RESPONSE TO REQUEST FOR ADDITIONAL INFORMATION

APR1400 Design Certification

Docket No. 52-046

RAI No.: 342-8291
SRP Section: 07.08 – Diverse Instrumentation and Control Systems
Application Section: 07.08
Date of RAI Issue: 12/18/2015

Figure 07.08-14-1 Configuration of DMA Switch and DMA Enable Switch

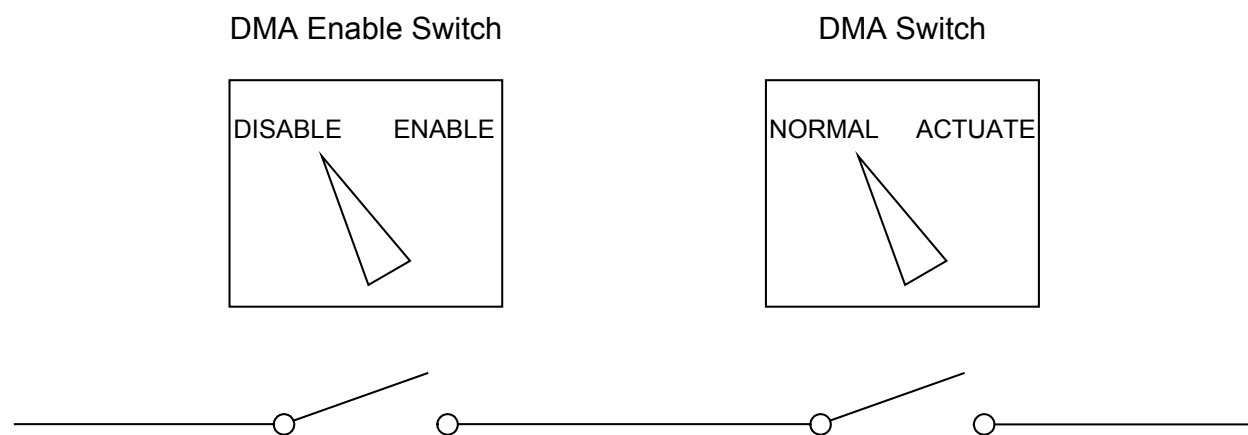
Clarify whether the Diverse Manual ESF [Engineered Safety Features] Action (DMA) enable switch is susceptible to a software CCF the safety system (including the PPS and ESF-CCS) and consequently prevent the DMA switches from performing their diverse functions.

Describe why the DMA enable switch is not susceptible to a software CCF in the safety I&C systems (including the PPS and ESF-CCS) and consequently prevents the DMA switches from performing their diverse functions. In the description, provide analysis and diagrams as necessary to illustrate the independence and the interface between the DMA enable switch and the safety-related I&C systems. In addition, is the DMA enable switch credited for the mitigation of a design bases event which occurs concurrent with a software CCF of the safety system? Update the FSAR documents and/or technical reports accordingly.

The DMA enable switch can block the hardwired signal from the DMA switch to the component interface module (CIM) by using an AND gate function, as shown in APR1400-Z-J-NR-14002-P, "Diversity and Defense-in-Depth", Figure 5-3. The AND gate function is implemented by a simple configuration using conventional hardwired switches, as shown in figure 07.08-14-1.

A DMA enable switch has contacts that are connected to each contact of the DMA switches in series, as shown in figure 07.08-14-1. The DMA enable switch can switch these contacts at the same time to enable the function of DMA switches. The operator needs to turn the DMA enable switch to "Enable" and then turn the DMA switch to "Actuate" to send an actuation signal. These actuation signals of the DMA switches are input to the CIM in the engineered safety features-component control system (ESF-CCS) loop controller (LC) cabinets through an interposing relay for isolation. Therefore, the signals from the DMA enable switch and the DMA switch are isolated from the safety I&C systems.
